# INTERNATIONAL ENERGY CONSERVATION CODE

## EC4-07/08

### 102.1.3, 102.1.3.1 (New), 202, Chapter 6 (New)

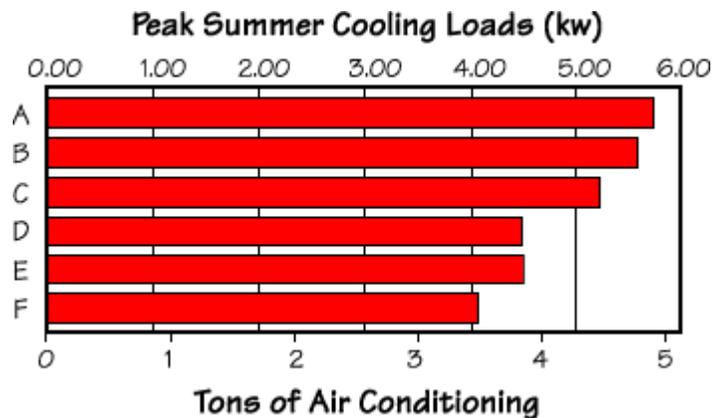
This modification cures this problem and secures the benefit of lower U-factors across-the-board to save energy all-year-round by simply eliminating the trade-off exception while recognizing the necessary improvement in window performance for climates that range from 7,200 to more than 12,000 Heating Degree Days during the heating season. It also responds the *IECC* Code Development Committee's accurate reasoning that, "Given that the advantages for SHGC gains depends upon the direction of the wall in which the windows are installed, the Committee believes that this provision is an oversimplification of the value of the tradeoff. This would be better dealt with in performance design."

We support lowering the U-factor to 0.32 in zones 6-8 without any exceptions because this would result in a guaranteed increase of almost 10% in window insulating value (almost a 10% reduction in heat loss through these windows) in these cold climates and guaranteed energy savings year-round in every home. A lower glazing U-factor is a proven energy saver for heating and cooling energy, so there will be savings on natural gas, heating oil and electric bills. Many windows sold in the northern U.S. that meet the 0.35 U-factor also meet the 0.32 U-factor. Typically, the difference between a 0.35 and 0.32 window is argon-fill, a fairly low cost option. While lowering the U-factor to 0.32 may be aggressive, the area weighted average approach incorporated into the code will allow some windows to exceed this value, so long as the windows selected for the home on average meet the 0.32 value.

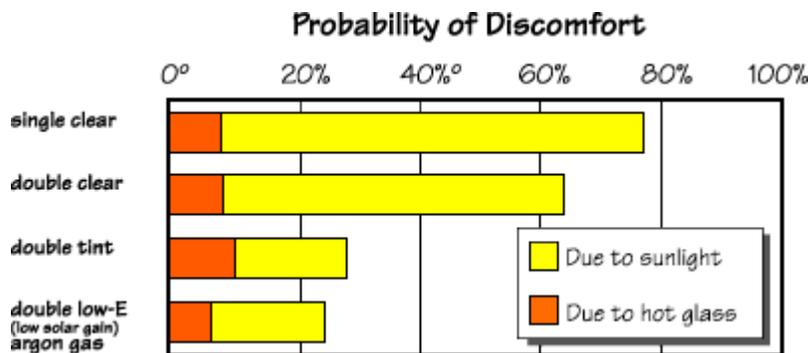
- Promotion of Higher SHGCs Would Negatively Impact Summer Comfort.** As written, EC21 encourages the installation of high solar heat gain glazing, regardless of the orientation, by establishing an exception to the lower U-factor. High solar gain will lead to significant occupant discomfort in the summer, even in colder climates (while possibly impacting winter comfort during the daytime). As explained by the EWC, as more direct sunlight passes through glazing, the probability of occupant discomfort increases enormously. The following chart provided by LBNL on the EWC website shows that use of a double pane clear window (with no low SHGC treatment) makes it almost three times more likely that the occupant will be uncomfortable, as compared to a sensible low SHGC low-e window. When occupants are consistently uncomfortable, they are likely to lower thermostat set-points in the summer and produce energy losses instead of savings (it is also possible in some cases that some may also lower their thermostats during the daytime during the winter).

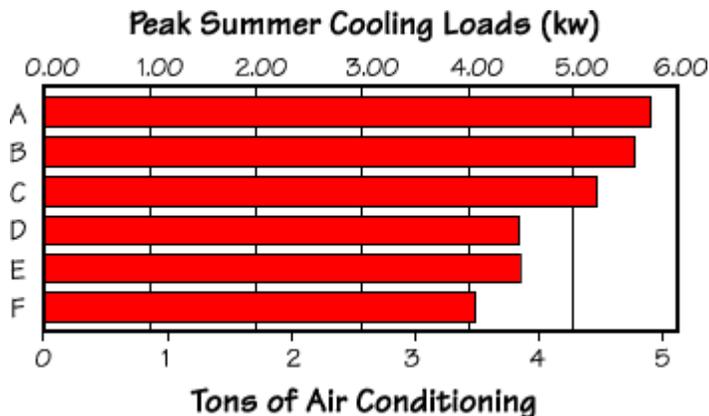
This modification cures this problem and secures the benefit of lower U-factors across-the-board to save energy all-year-round by simply eliminating the trade-off exception while recognizing the necessary improvement in window performance for climates that range from 7,200 to more than 12,000 Heating Degree Days during the heating season. It also responds the *IECC* Code Development Committee's accurate reasoning that, "Given that the advantages for SHGC gains depends upon the direction of the wall in which the windows are installed, the Committee believes that this provision is an oversimplification of the value of the tradeoff. This would be better dealt with in performance design."

We support lowering the U-factor to 0.32 in zones 6-8 without any exceptions because this would result in a guaranteed increase of almost 10% in window insulating value (almost a 10% reduction in heat loss through these windows) in these cold climates and guaranteed energy savings year-round in every home. A lower glazing U-factor is a proven energy saver for heating and cooling energy, so there will be savings on natural gas, heating oil and electric bills. Many windows sold in the northern U.S. that meet the 0.35 U-factor also meet the 0.32 U-factor. Typically, the difference between a 0.35 and 0.32 window is argon-fill, a fairly low cost option. While lowering the U-factor to 0.32 may be aggressive, the area weighted average approach incorporated into the code will allow some windows to exceed this value, so long as the windows selected for the home on average meet the 0.32 value.

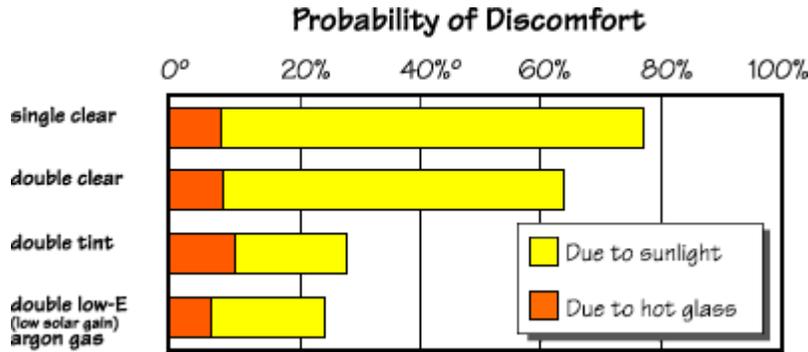
2. **Promotion of Higher SHGCs Would Negatively Impact Summer Comfort.** As written, EC21 encourages the installation of high solar heat gain glazing, regardless of the orientation, by establishing an exception to the lower U-factor. High solar gain will lead to significant occupant discomfort in the summer, even in colder climates (while possibly impacting winter comfort during the daytime). As explained by the EWC, as more direct sunlight passes through glazing, the probability of occupant discomfort increases enormously. The following chart provided by LBNL on the EWC website shows that use of a double pane clear window (with no low SHGC treatment) makes it almost three times more likely that the occupant will be uncomfortable, as compared to a sensible low SHGC low-e window. When occupants are consistently uncomfortable, they are likely to lower thermostat set-points in the summer and produce energy losses instead of savings (it is also possible in some cases that some may also lower their thermostats during the daytime during the winter).

**FIGURE N1102.1  
PROJECTION FACTOR**

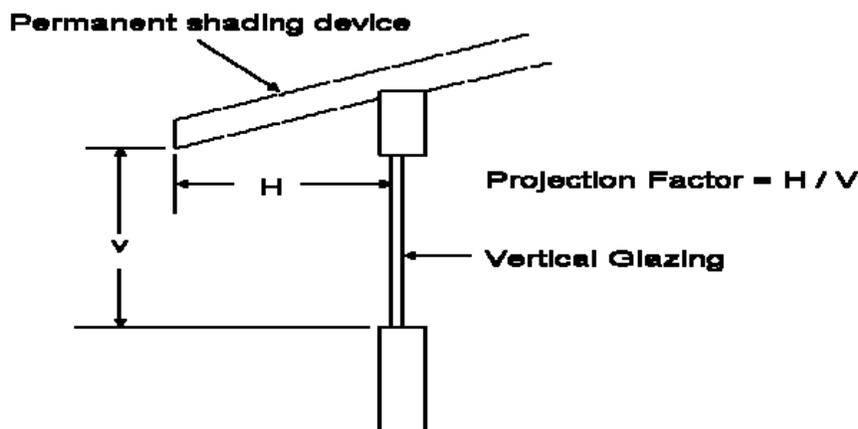
h. Fenestration with a projection factor of  $\geq 0.50$  shall comply with the following SHGC requirements: Climate Zone 1- NR; Climate Zone 2- NR; Climate Zone 3 - NR. Projection factor shall be determined using Figure 1102.1.

**Reason:** This proposed code change allows for the use of overhangs to meet the solar heat gain coefficient requirements within the IRC. Overhangs are considered permanent exterior shading devices and are allowed to be used in IECC Chapter 5 as a prescriptive trade-off to meeting the SHGC requirements within the code. The calculation for determining the projection factor for overhangs has been in the 2000,

h. Fenestration with a projection factor of  $\geq 0.50$  shall ~~be deemed to comply with the following~~ SHGC requirements in Climate Zones 1 through 3. ~~Climate Zone 1 – NR; Climate Zone 2 – NR; Climate Zone 3 – NR.~~ Projection factor shall be determined using Figure N1102.1.

h. Fenestration with a projection factor of  $\geq 0.50$  shall be deemed to comply with the SHGC requirements in Climate Zones 1 through 3. Projection factor shall be determined using Figure N1102.1. The minimum horizontal distance of an overhang on each side of a window should be greater than or equal to the depth of the overhang (the distance from the surface of the window to the farthest most point of the projection).

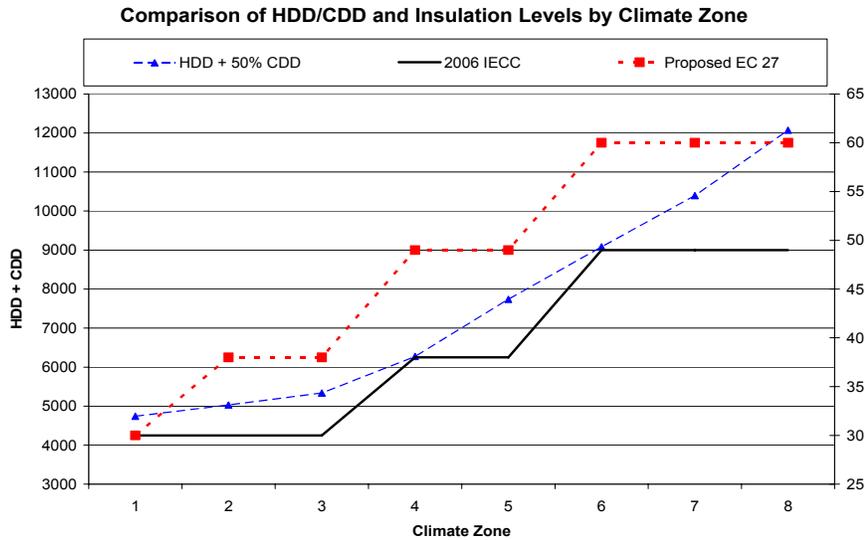
The U.S. Department of Energy issued new recommendations for cost-effective insulation levels in new homes in early 2008. The R-values proposed in EC-27 are consistent with those recommendations.

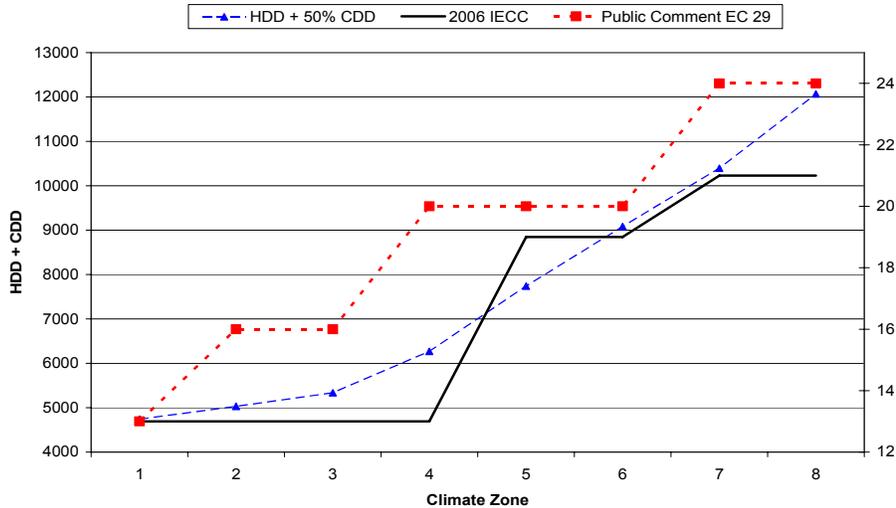
The most critical of the climate zones in this proposal is Climate Zone 4, which includes nearly 25% of all new housing starts in the country and currently has the same wall insulation requirement as Climate Zone 1; it simply does not make sense that Dade County (Miami, FL) and St. Louis County (Missouri) would have the same wall insulation requirements. In Climate Zone 4, by upgrading the wall insulation level to R-20 (or R-13 cavity plus R-5 sheathing), which is consistent with the R-Value approved by the committee in proposal EC-28 in Climate Zone 5 and Marine Climate Zone 4, with technologies that are readily available, the savings are significant, at 8% of total purchased energy. This analysis was conducted using the DOE-2 simulation model, and was based on the IECC methodology for calculating purchased energy.

A well-designed set of energy code thermal criteria would match R-values to weather-related energy loads. Heating and Cooling Degree Days (HDD and CDD) are accepted indicators of the impact of weather-related loads on the energy use of the home. In the graph below, we draw a simple comparison between HDD plus 50% CDD to IECC wall insulation criteria. The graph shows that the current 2006 IECC does not increase wall insulation criteria proportionally to the increase in weather-related load. The proposed wall criteria in our public comment on EC-29 would match IECC wall criteria more closely to weather loads.

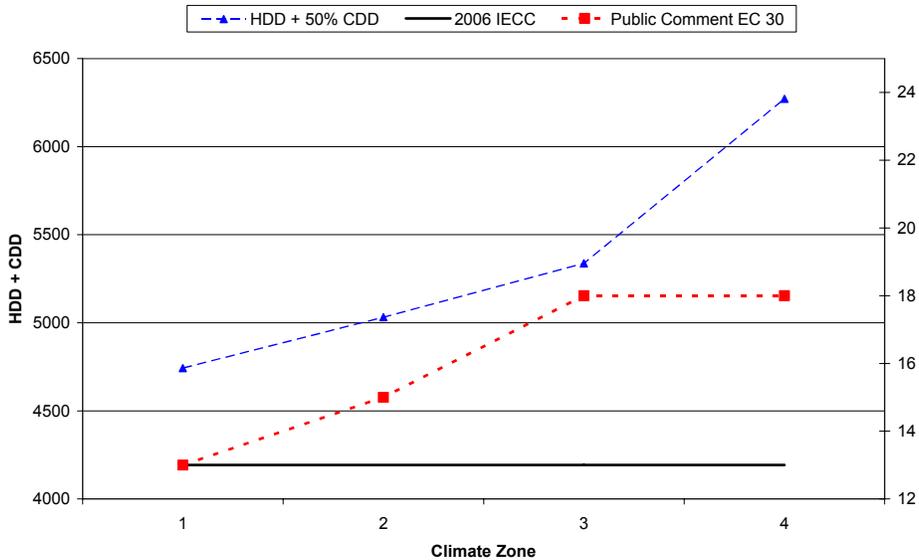
A well-designed set of energy code thermal criteria would match R-values to weather-related energy loads. Heating and Cooling Degree Days (HDD and CDD) are accepted indicators of the impact of weather-related loads on the energy use of the home. In the graph below, we

draw a simple comparison between HDD plus 50% CDD to IECC wall insulation criteria. The graph shows that the current 2006 IECC does not increase in wall insulation between Climate Zone 1 and 4, even though heating and cooling loads increase by over 30%. The proposed wall criteria in our public comment on EC-30 would match IECC wall criteria more closely to weather loads.
